Bayside Planning Panel

Item No	6.4
Application Type	Development Application
Application Number	DA-16(193)
Lodgement Date	26/10/2017
Property	9-17 Byrnes Street, Botany
Owner	Andrew & Basil Micos
Applicant	Solutions Zane
Proposal	Continued use of the existing industrial premise for warehouse and distribution, use for the manufacture of aluminium glass doors and windows, use as a freight transport facility, and use as a vehicle repair station,
No. of Submissions	Nil
Cost of Development	\$40,000.00
Report by	Christopher Mackey, Coordinator Development Assessment

BAYSIDE COUNCIL Planning Assessment Report

Application Number:	Section 82A review of Determination of DA16/193
Date of Receipt:	24 October 2017
Property:	9 – 15 Byrnes Street, Botany Lot 7 -10 DP 28449
Owner:	Con Micos Estate Pty Ltd
Applicant:	Solutions Zane (Land Use Planning Services)
Proposal:	Section 82A Review of Determination of the refusal of Development Application 16/193 for the continued use of existing industrial premises for warehouse and distribution, use for the manufacture of aluminium glass doors and windows, use as a freight transport facility, and use as a vehicle repair station.
Value:	N/A
No. of submiss

16.441 - TX.01 -
	project no. drawing phase. drawing no. rev

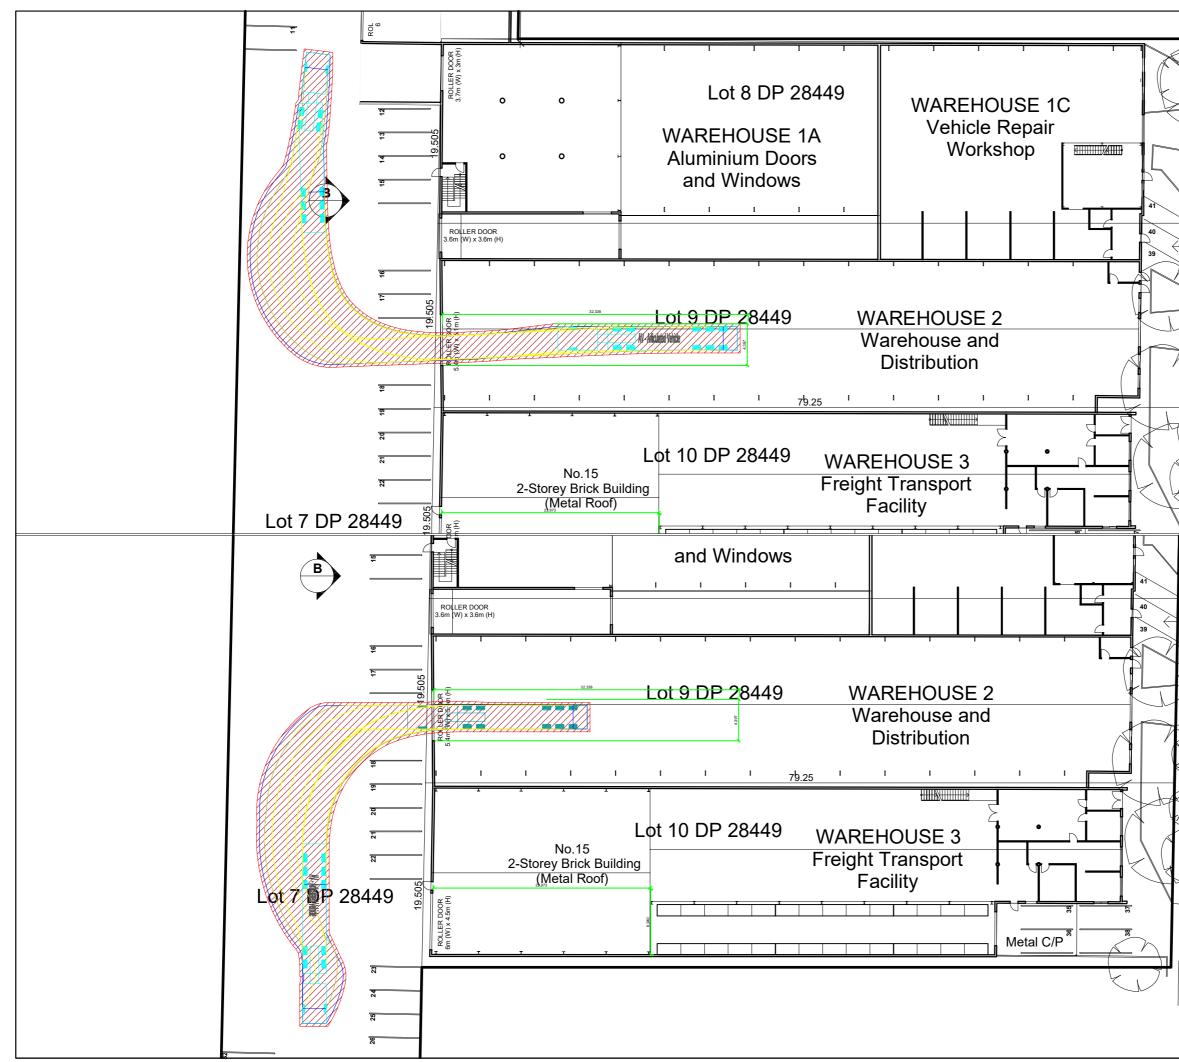
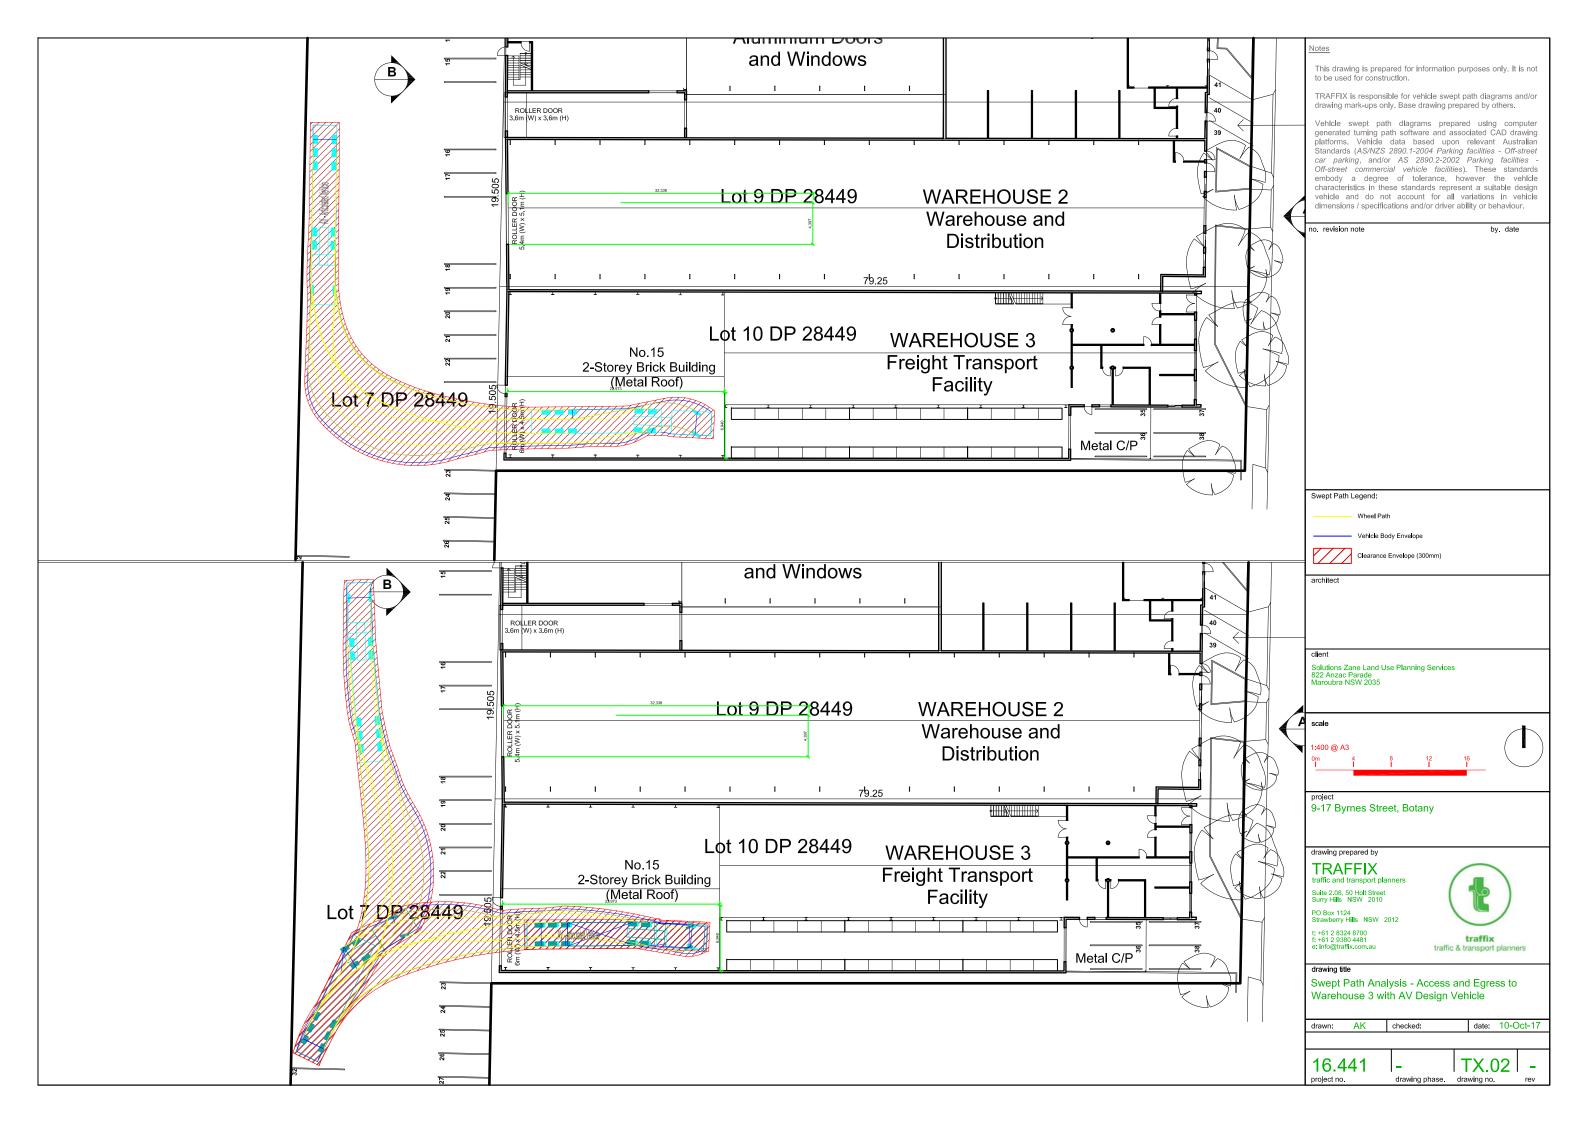
Appendix C drawings TX.01 and TX.02 of the revised Traffic Report, show swept paths analysis, compliant with the requirements of the relevant Australian Standards, demonstrating the ability for a 19m AV design vehicle to enter and exit the site and respective warehouses, in a forward direction, without impacting on designated onsite carparking spaces.

Appendix C drawings TX.01 and TX.02 detail the nominated clearance areas within Warehouses 2 and 3, compliance with which would be facilitated by line marking on the floors of each respective warehouse. This could be managed by way of an appropriate condition of consent.

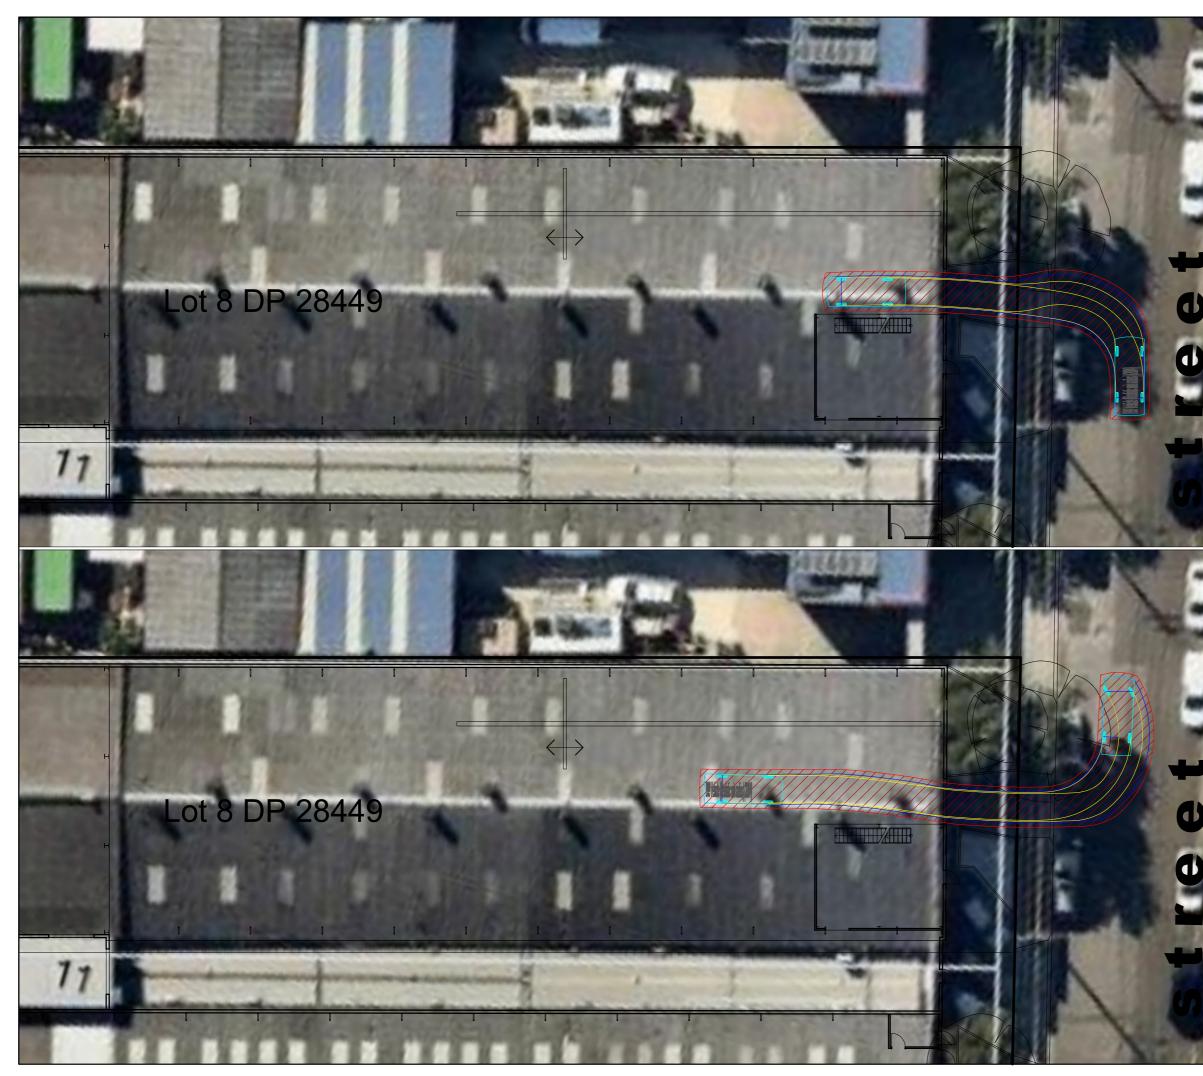
Appendix C drawings TX.02-TX.09 of the revised Traffic Report show the swept paths analysis for a 19m AV from the northern and southern approaches to the site, demonstrating compliance with the relevant Australian Standards, in accordance with the detail requested by Council. Section 7.1 of the revised Traffic Report recommends a 10.2m "No Parking Zone" between 7.00am and 6.00pm, Monday to Friday, on the southern side of Erith Street, east of the existing access, to provide for unhindered access of a 19m AV during the operating hours of Warehouse 2 and 3. The conclusion in the revised report demonstrates a sustainable impact on the surrounding street network notwithstanding this minor alteration to existing on-street conditions.
